**United Walnut Taxpayers (UWT)**  
**P.O. Box 1665**  
**Walnut, CA. 91788**  
**Contact Person, Layla Abou-Taleb, President**

**UWT Response to the July 2017 NOC of Tiered Draft EIR for the Mt. SAC West Parcel Solar Project**

**Response to EIR Section 3.5 Geology and Soils, West Parcel Area, Mt. San Antonio  
College, August 2017** PDF Page 49

**Photo 1**

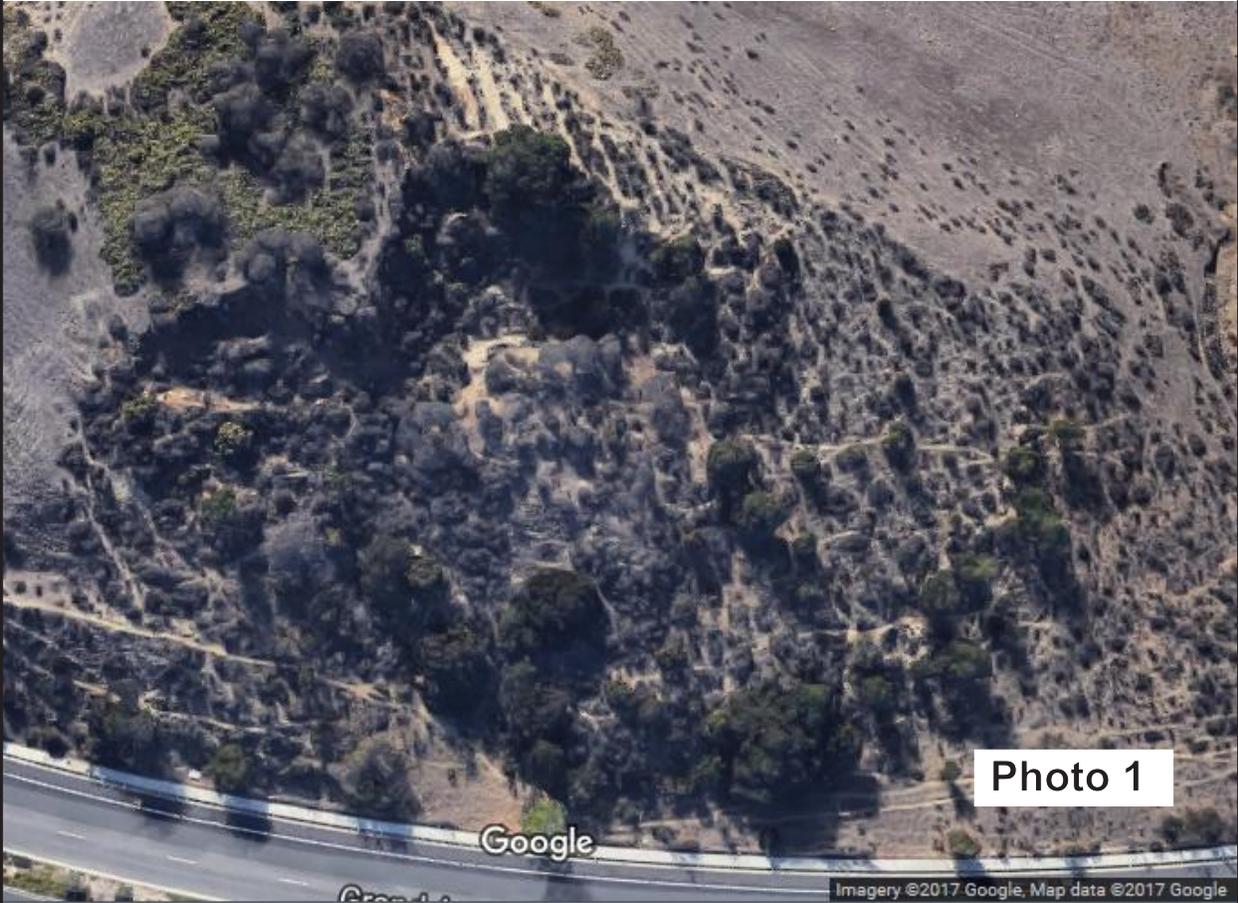
Remediation of the landslide materials that exist within the central hillside area, and other areas of the site, will consist of total removal of the landslide debris to competent bedrock. In addition to normal remedial removals a thorough evaluation, including subsurface investigations, of the underlying weak bedrock conditions must be conducted to determine the width and depth of a shear key that will likely be necessary to stabilize the proposed development. The Converse report indicated that a “Fill Slope Stabilization Keyway” was necessary for portions of the site (Drawing No. 2). However, their key was not based on specific slope stability analysis and was not recommended for cut slopes and/or areas of landsliding or potential slope stability issues.

**Figure 1**

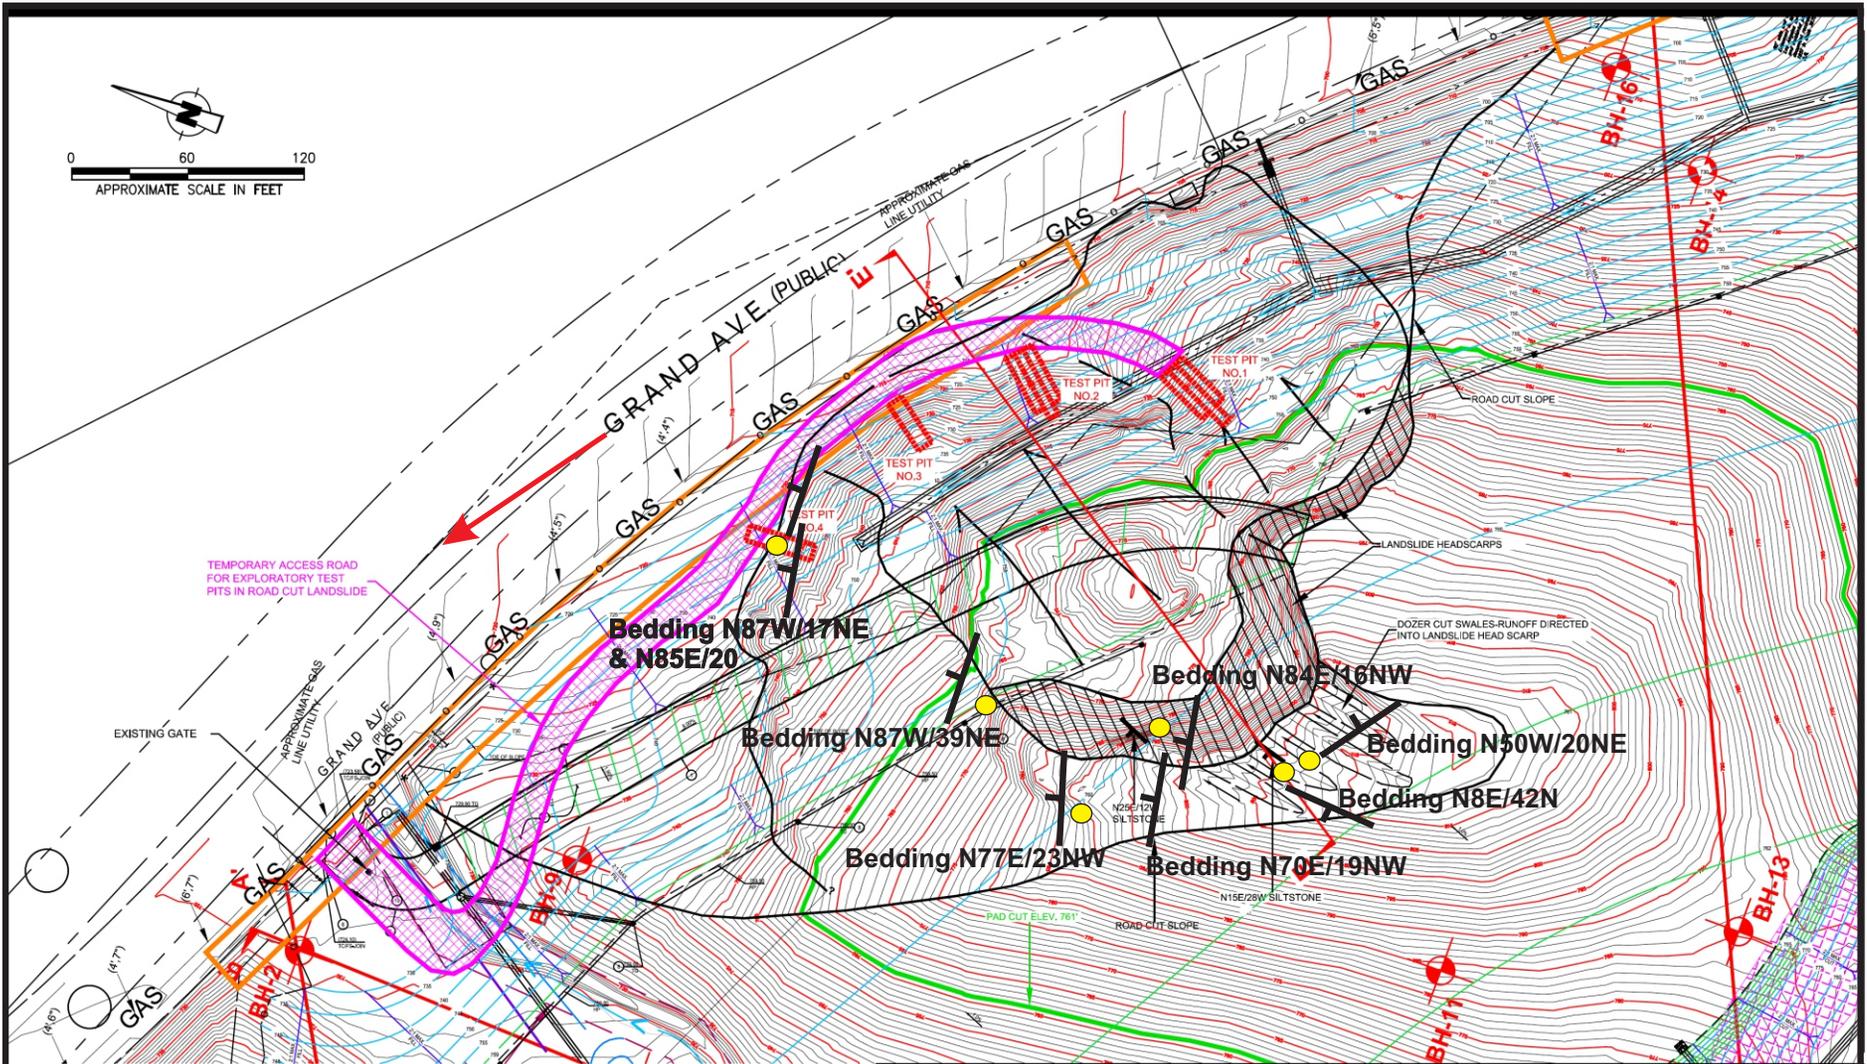
The Converse report identifies a landslide in all four of the test pits excavated, and Drawing No. 1 has several lines possibly indicating the limits of the landslide or several landslides. The limits of the landsliding is unclear because not all lines are labeled and no legend is provided for Drawing No. 1. Four arrows are shown that likely indicate the direction of landsliding (one or two landslides) however, in the area of Test Pit No. 4 there are no arrows and the line which may show the limits of landsliding is discontinuous to the west and ends with a question mark. An area that is indicated as landslide headscarp is indicated on Drawing No. 1. There is no discussion in the text of the report regarding multiple landslides, multiple pieces of the same landslide, or the limits of landsliding.
